Central Zoo Authority

Sub:- Design for the construction of various enclosure at Nahargarh Biological Park, Jaipur.

The design for the construction of various enclosures at Nahargarh Biological Park, Jaipur was placed before the 45th Meeting of the Expert Group on Zoo Designing of the Central Zoo Authority held on 30th October, 2013. After detailed deliberation, the following observations were made:-

HOG DEER ENCLOSURE

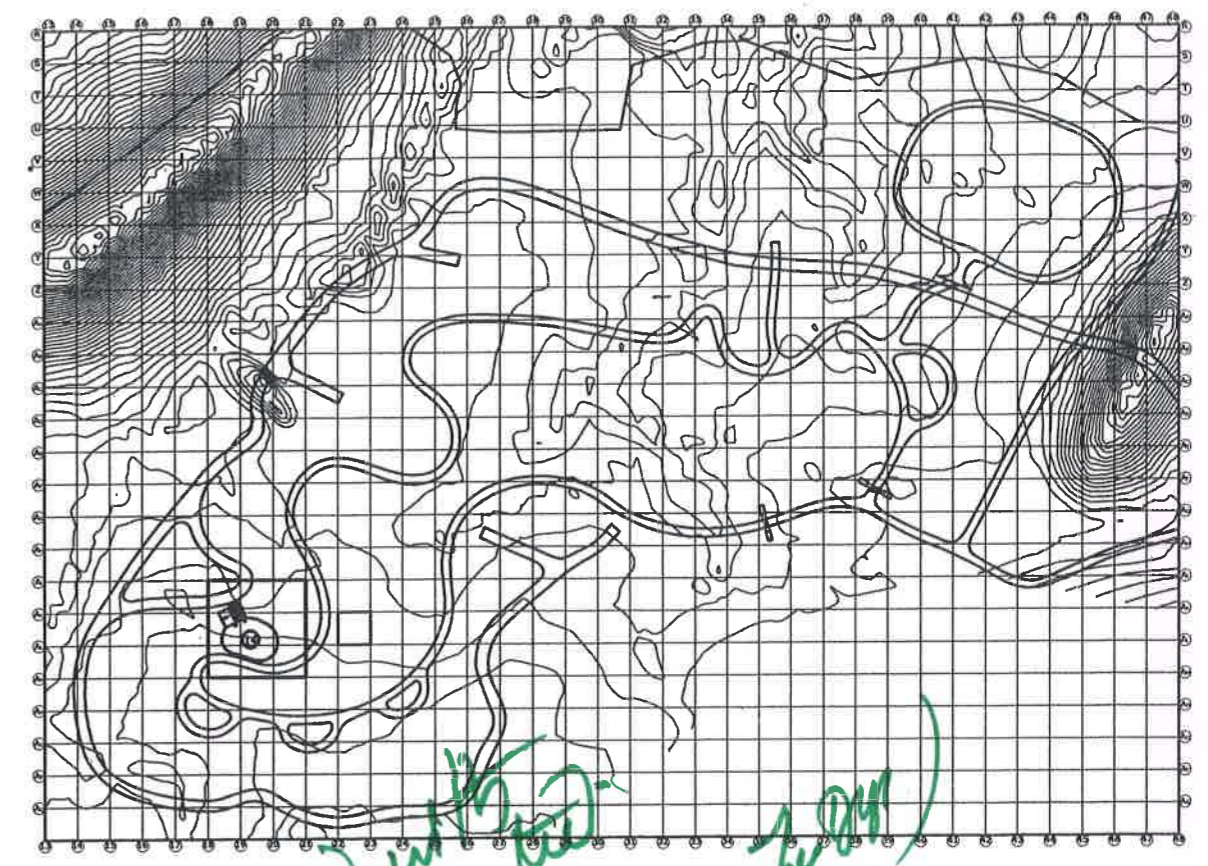
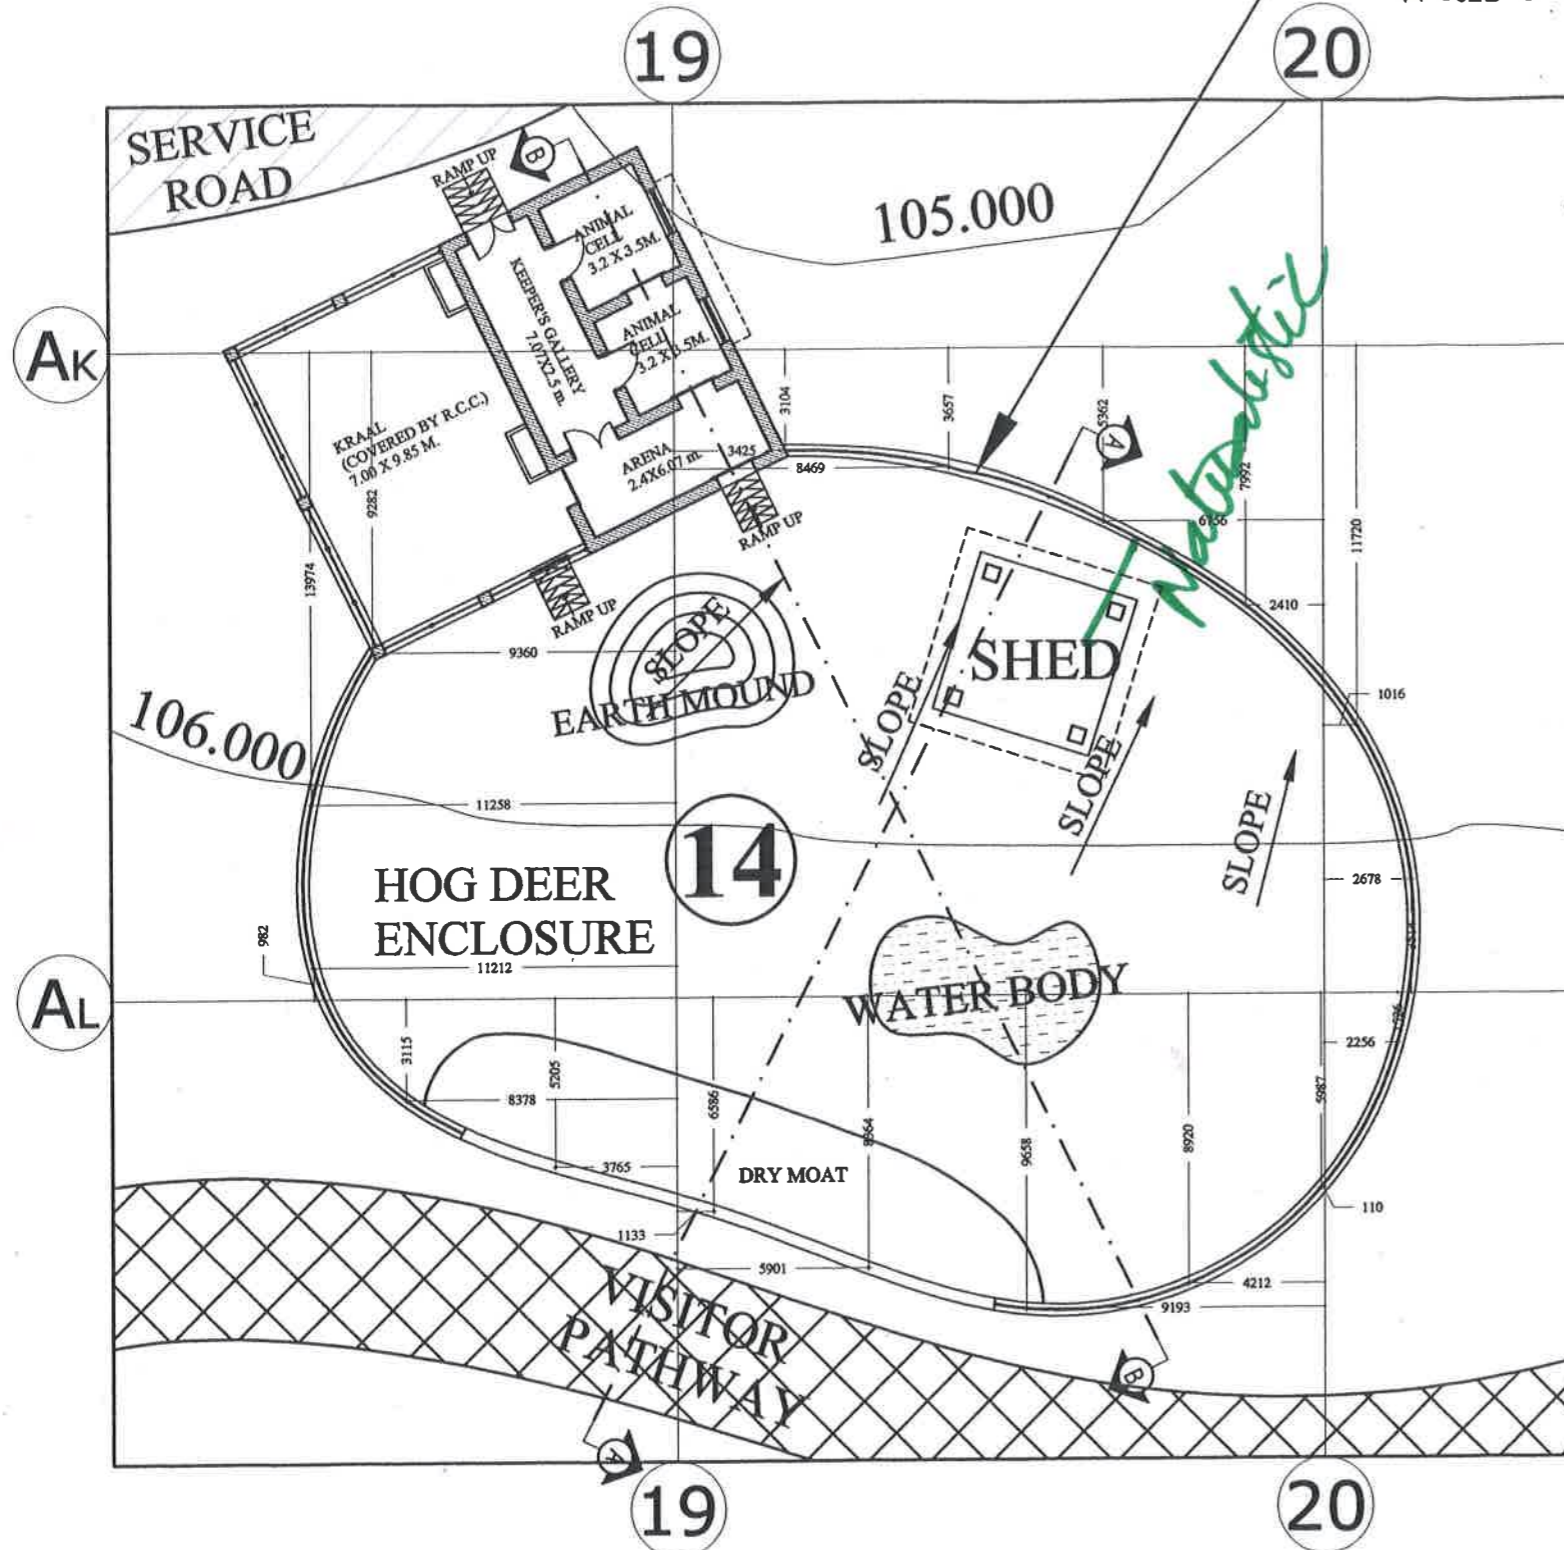
The design was approved subject to the amendments as indicated on the designs and following:-

- (a) The top of kraal should be covered by chain-link mesh.
- (b) There is no need of inclined barrier/ overhang.
- (c) The height of chain-link fence should be 2.5 mt. only.

Chain link Fence 75mm x75mmx10 g (3 m high) on 23A
 375mm th.& 600mm high Stone Masonry wall
 with 60° inclined 1.5 m overhang with barbed wire

DRAWING TITLE: **PROPOSED WORKING SECTION FOR HOG DEER ENCLOSURE**

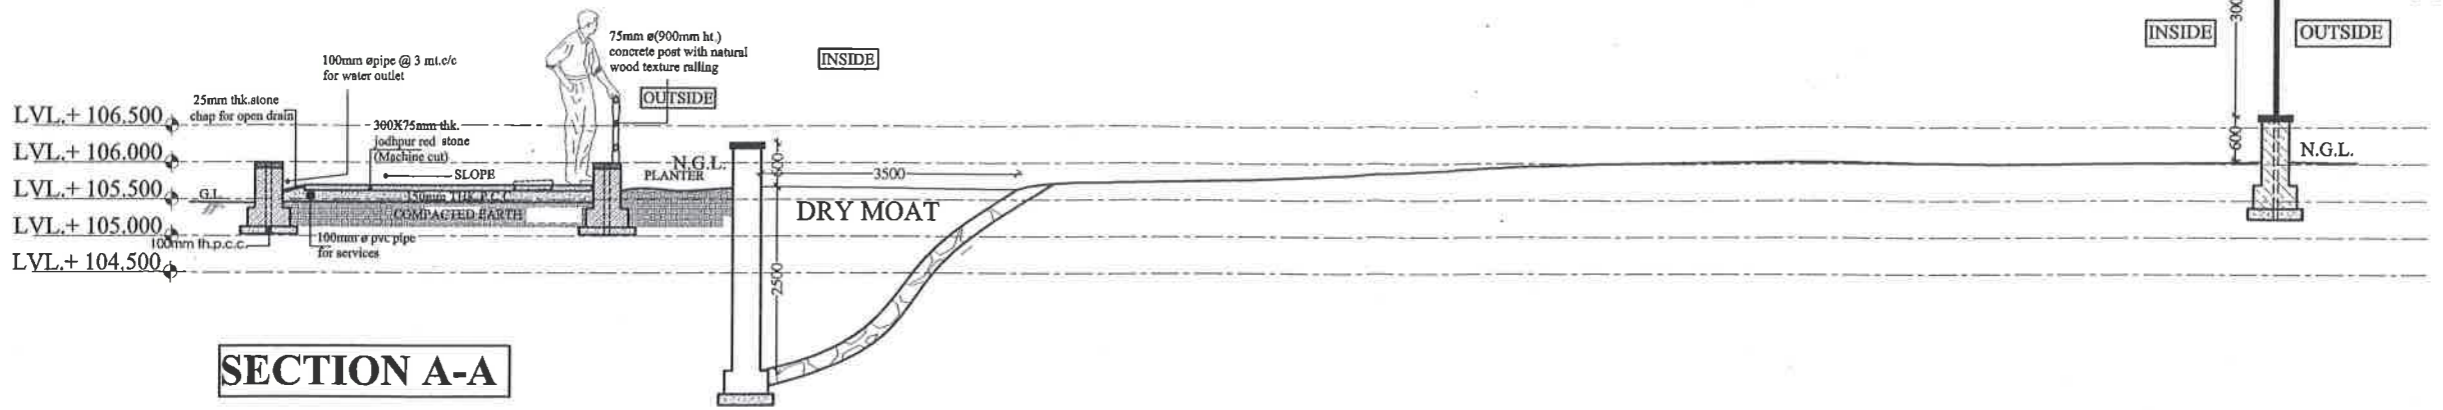
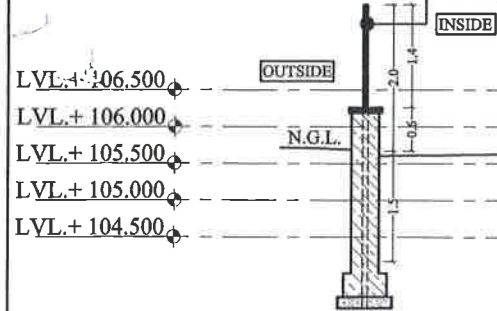
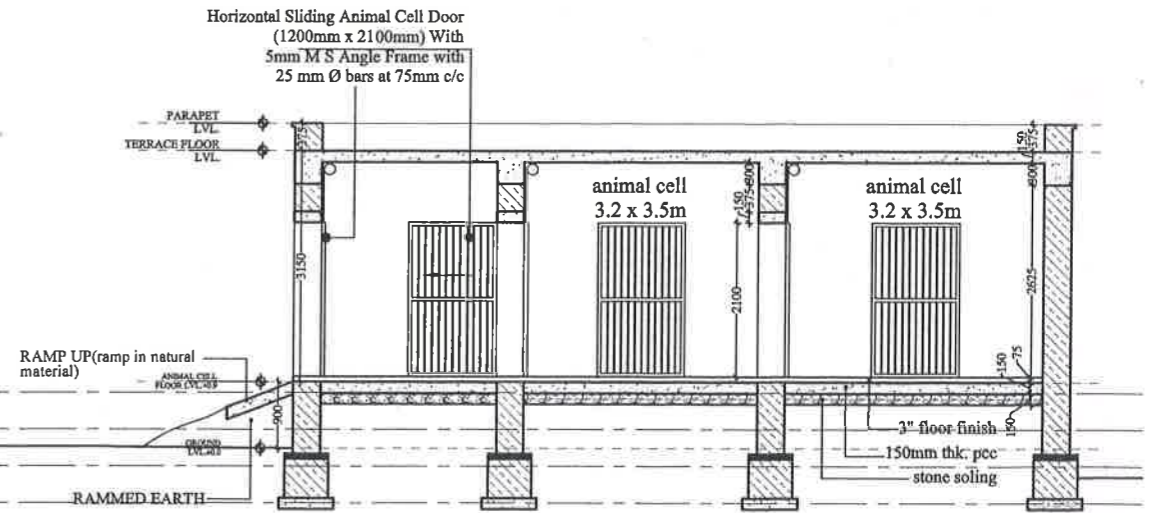
Chain link Fence 75mm X 75mm X 10g 1.4 mtr high fixed on 50x50x6mm post on 375mm th. & 600mm high stone masonry wall
